REMEDICATION SYSTEM EVALUATION (RSE)

ELLIS PROPERTY SUPERFUND SITE
EVESHAM AND MEDFORD TOWNSHIPS, NEW JERSEY

Report of the Remediation System Evaluation
Site Visit Conducted April 19, 2006

Final Report
September 2006

Figure 1-2 Extent of VOC contamination

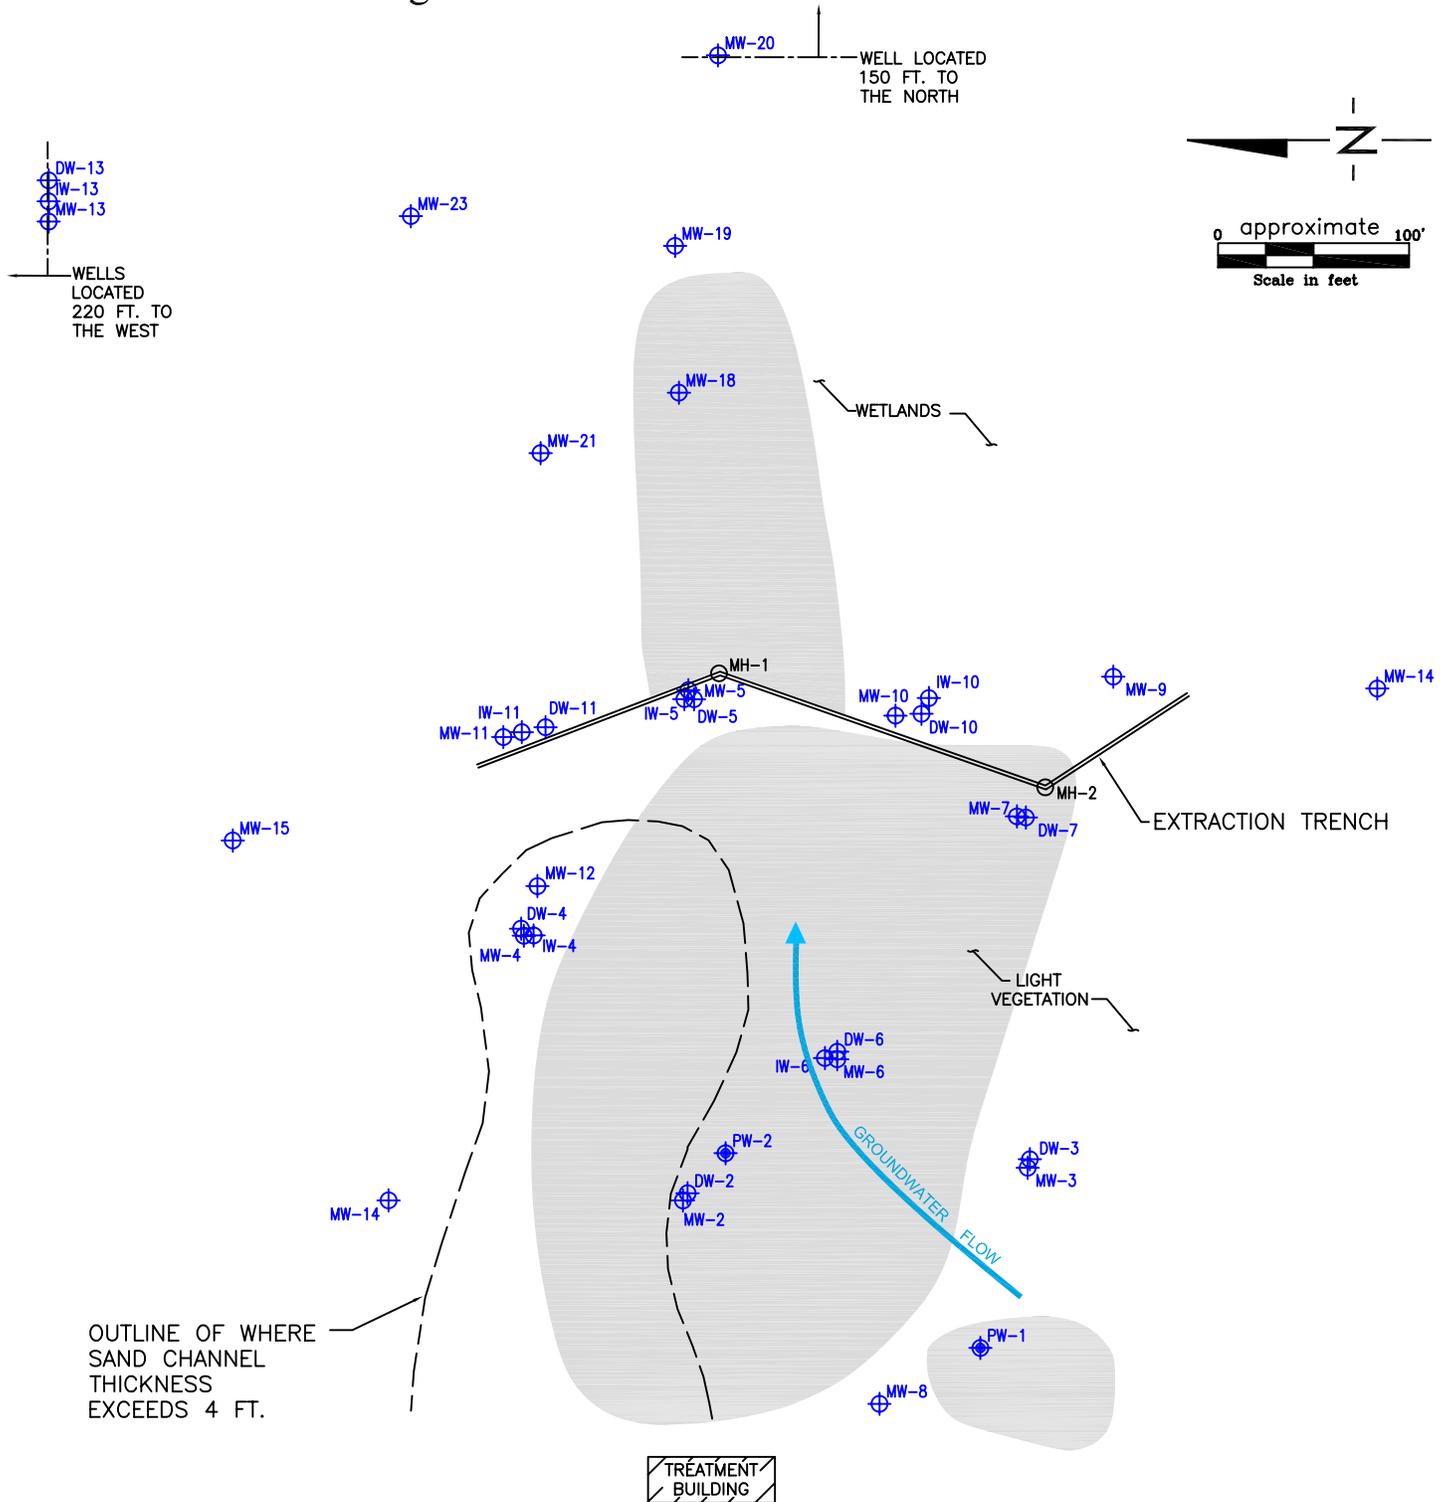
The contaminants of concern at the site are TCE and PCE. Figure 1-2 (with information gathered from Figure 6 of the November 2005 Pre-Design Investigation Workplan) shows interpretations of the TCE and PCE distributions at the site as of October 2004. Based on this map the TCE plume appears to extend from behind the treatment facility in the vicinity of MW-8 into the wetlands in the vicinity of MW-19. The following table indicates TCE concentrations from three recent sampling events.

TCE concentrations in the source areas in the vicinity of MW-2 and MW-6 consistently remain elevated above 5,000 ug/L, but this represents a decrease from high concentrations above 60,000 ug/L in MW-2 and 30,000 ug/L in MW-6. These persistently elevated concentrations may indicate that residual source material remains in these areas and/or that the formation is relatively tight such that the contamination is not easily flushed toward the extraction trench. TCE concentrations at MW-5, MW-7, MW-8, MW-10,
